Determination 2025/029

An authority's decision to issue three notices to fix for building work done without a building consent

8-12 Wren St, Taihape, Rangitikei

Figure 1: Photo showing the building work

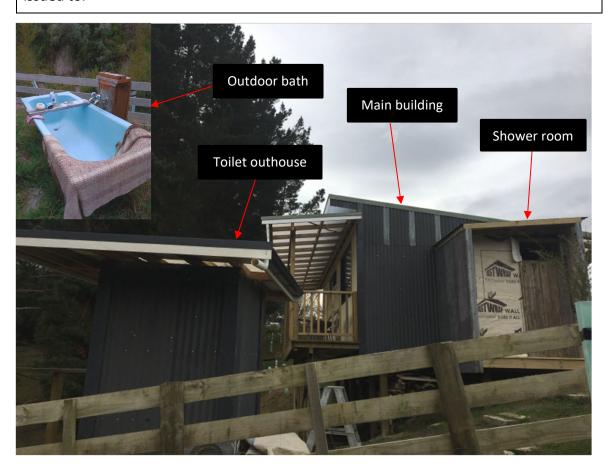
- 4.14. Based on the photographs provided, the main building has timber pile foundations that do not extend above the subfloor. It has covered decks, windows, a glazed sliding door, carpet, a kitchen bench with a sink, and a shower room with a shower, hand basin and a gas water heater.

- 4.16. The features of the outdoor bath, toilet outhouse and main dwelling are not indicative of buildings that could properly be described as pole sheds or haybarns. Rather the features indicate these were constructed for normal occupation or use by people

- 4A could apply in the circumstances would be inconsistent with the purpose of Schedule 1 and, more broadly, the purposes of the Act.¹⁰
- 4.18. Even if I was wrong on this point and the main building could be categorised as a pole shed or haybarn, one of the conditions in clause 4A is not met. The rear deck at its highest point is approximately 2 metres above the ground; clause 4A(1)(b)(i) provides that the floor level of the building must not be more than 1 metre above the supporting ground.

6.1 In accordance with section 188 of the Building Act 2004, I determine that the authority had grounds to issue notice to fix NTF0426 in relation to the main building and notices to fix NTF0432 and NTF0439 in relation to the main building, the toilet outhouse and the outdoor bath. The particulars in each of these notices to fix are deficient, and I reverse all three notices.
